JABIRU AIRCRAFT PTY LTD

SERVICE BULLETIN: **JSB 029-1**

Subject: **J170 Handling Upgrade**

Figure 2 – New Rudder Centring Springs

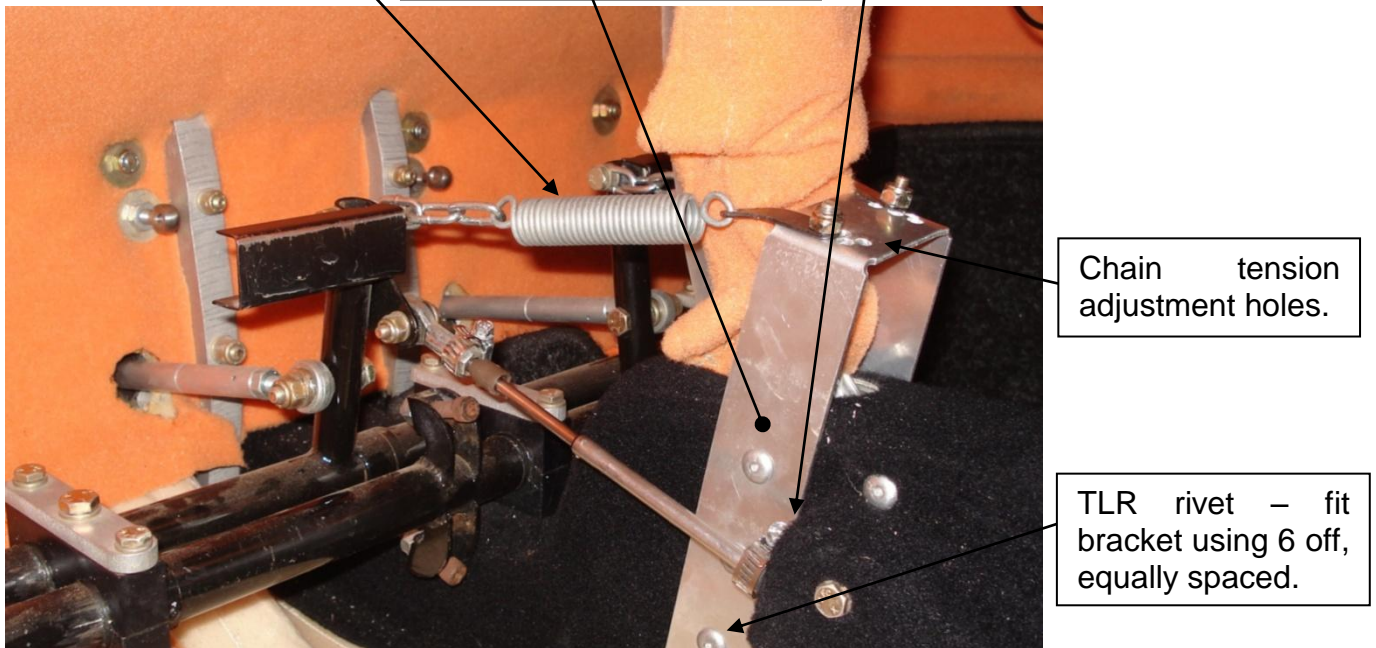
- Remove the existing rudder springs and chains from the rudder pedals.
- Fit the new spring mounting bracket to the aircraft's centre console using 6 off TLR rivets as shown in Figure 2. The exact position is not critical – but it should be aligned with the front of the rudder cable mount and positioned so that the chains and springs run as straight as possible.

- Fit the new springs as shown in Figure 2. Adjustment of these springs is important for correct handling of the aircraft. The springs must be set so that when the rudder pedals are centered neither spring is carrying any load – but as soon as the pedals move slightly a spring takes up tension. If the springs are set too tight – i.e. when the pedals are centered both springs are carrying some tension – this will reduce the centring effect of the spring system and must be avoided. If the springs are set too loose the pedals must move too far before there is any centring effect – this makes the system ineffective near centre and must also be avoided.

New rudder centring spring & chain assembly

Spring anchoring bracket – rivet to centre console

Align rear of bracket to front of rudder cable mount

Figure 3 – Fitting Adaptor to Drive Arm

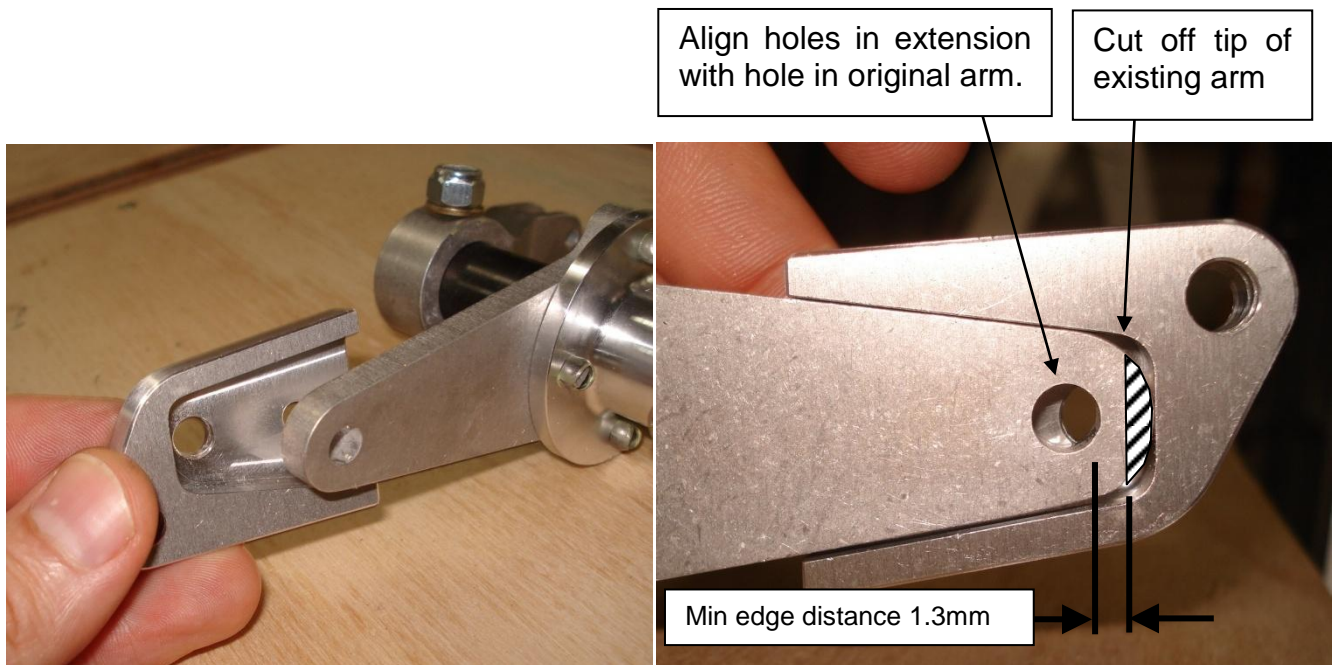
- Apply the new drive adaptor to the existing internal flap drive arm from the outboard side – it will be obvious how much material must be removed from the existing arm to fit the adaptor. Figure 3 (right) shows this. Carefully remove this material, removing just enough so that the extension slides onto the arm far enough to align the bolt holes and to fit snugly around the arm. De-burr the tip. Note the minimum edge distance shown in Figure 3 (right).

- The adaptor can now be placed on the inboard side of the flap drive arm and used as a guide to drill the new 3/16” hole. Carefully drill through the hole on the adaptor and through the existing drive arm.

Figure 4 – Adaptor in Place

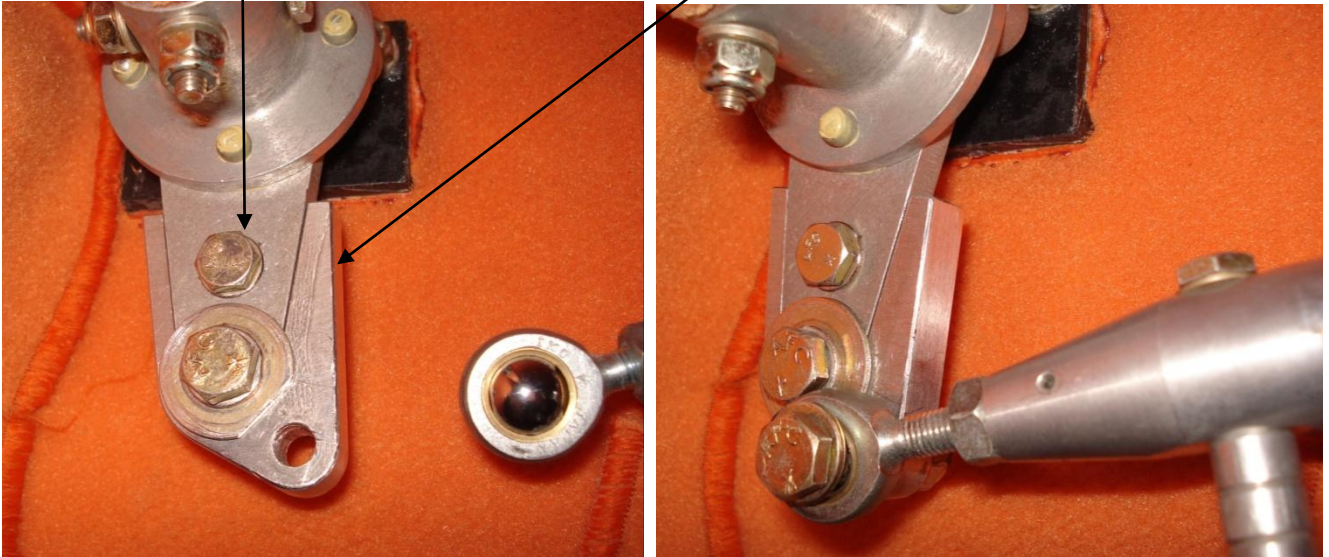
- Remove the adaptor from the drive arm. Clean it using Acetone. Mix and apply 5-minute epoxy resin to its socket.
- Bolt the adaptor to the arm using 1 off ¼” and 1 off 3/16” bolts, orienting it as shown in Figure 4. Wipe off any excess resin. Both bolts can be fitted from the cabin side of the drive arm – care will be needed to use the correct length bolt so that the tails of the bolts do

Use the 3/16" hole in the adaptor as a guide to drill a matching hole in the existing arm

Adaptor bolted & bonded in place. Use of penny washer is optional.

Figure 5 – Flap Drive Modification

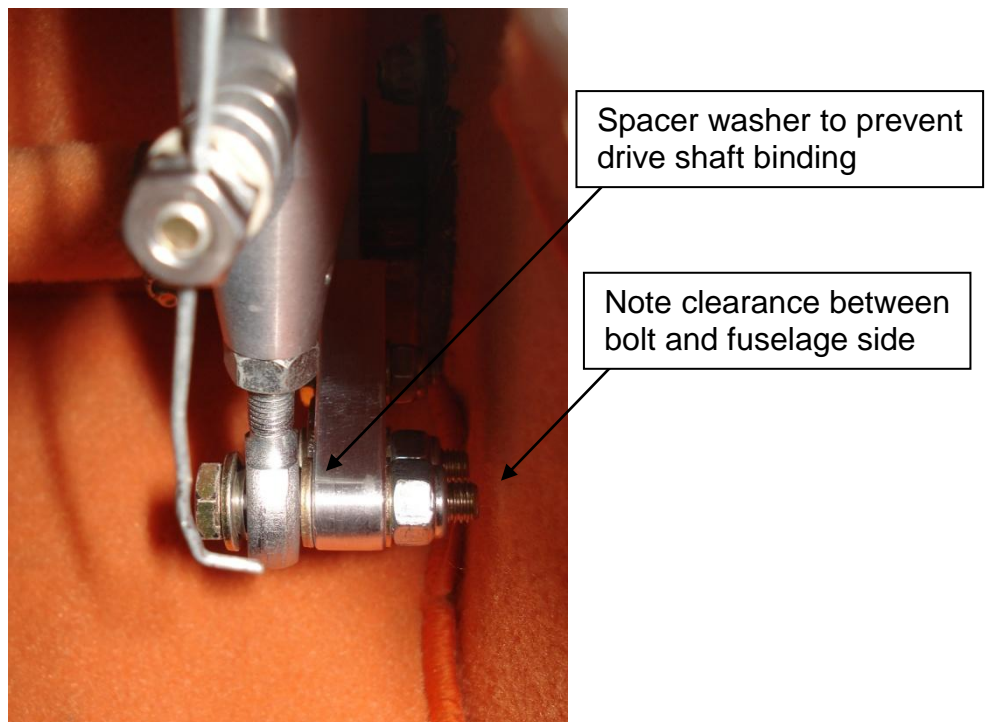
- Turn the aircraft master power on and drive the motor to the fully “down” position, then turn the master power off.
- Once in position, adjust the rod end in the motor shaft to align with the lowest hole in the adaptor and re-connect it using a ¼” bolt. Note that if there is not enough adjustment in the rod end the external flap drive pushrods can be adjusted to suit. Again, AN363 or MS21042 nuts may be used if required to give clearance from the fuselage.

- Remove the tape or stands from the flaps.
- Turn the aircraft master power on and cycle the flaps, checking for smooth operation with no binding or other issues. Measure the flap deflection – between full up and full down positions the flaps must travel $30^{\circ} \pm 1.5^{\circ}$.

Figure 7 – New Ventral Fin Fitted

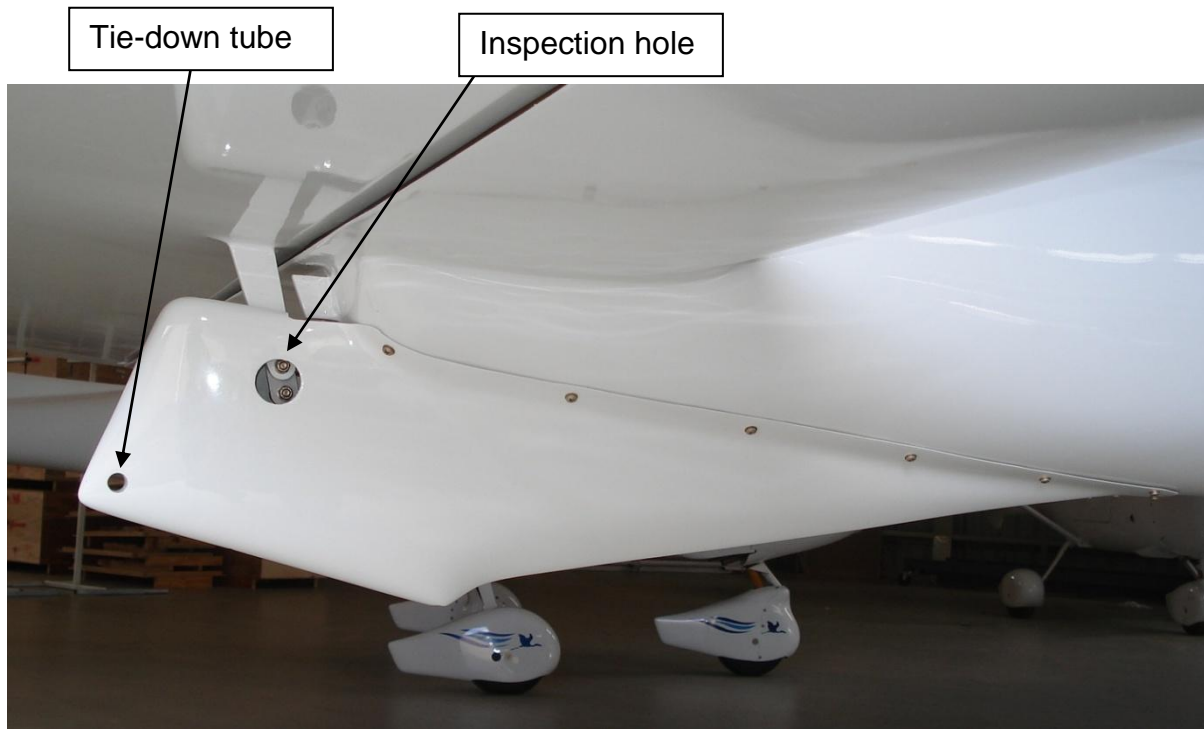
- Remove the existing ventral fin and weigh it accurately.
- Cut the inspection hole and fit the tie-down tube to the new ventral fin. Drill two ¼” drain holes in the bottom of the fin at the positions indicated in Figure 7. Paint to match the aircraft.

- Match drill the replacement fin mounting screw holes to the original part. Note that although the replacement fins are supplied with pilot holes drilled the exact hole positions must be found by comparison to the original parts.

- Weigh the replacement fin accurately.
- Fit the new fin.
- Some J170 aircraft operate quite close to the rear of their CG envelope and in some cases the extra weight added by this new ventral fin will be sufficient for the aircraft to exceed its rear CG limit in some load cases. Operators must calculate the effect that changing this part has had on their aircraft and assess if any ballast or operating changes are required. Depending on the category in which the aircraft is operating these calculations may need to be carried out by an approved Weight Control Authority.
